Access Compliance Report

Public Rights-of-Way

Intersection ID: 17802	Main Street: HAVEN_DR	Cross Street: REECE_RD	Location: SE
ADA ID: 15D241392D25	Ramp Type: BlendTrans1	Initial Pass/Fail: Pass	Overall Compliance: No
		Severity Score: 24

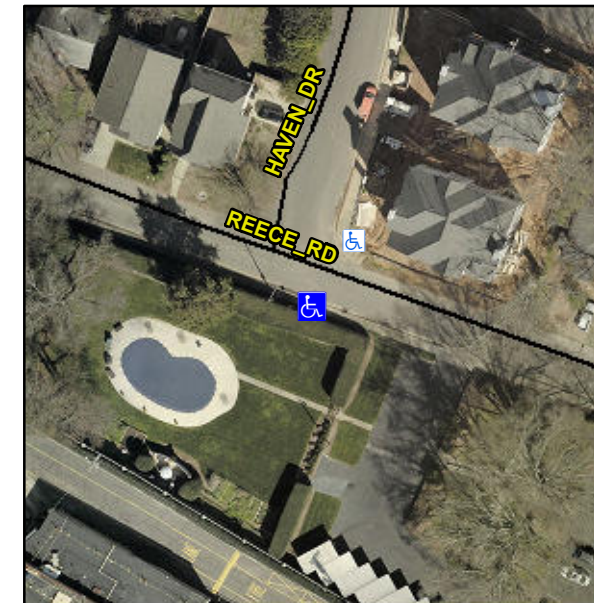
Not Found, R304.2.1, R302.7, R302.7.2, R304.5.4

N/A	Ramp inside XWalk1?	N/A	N/A	Ramp inside XWalk2?	N/A
	Road Slope (%)	0.2		Clear Space?	Yes
	Road X Slope (%)	4.3	N/A	Clear Space to XWalk (in)	N/A
Yes	Any Obstructions?	No	Yes	Storm Grate/Utility Hazard?	No
	Obstruction Type			Storm Grate/Utility Type	
		N/A			N/A
			Yes	Surface Condition? (G/P)	Good
			No	Curb Slope (%)	14.8

Remove & Replace Curb Ramp With Two New Directional Ramps or Equivalent. Remove & Replace Gutter.
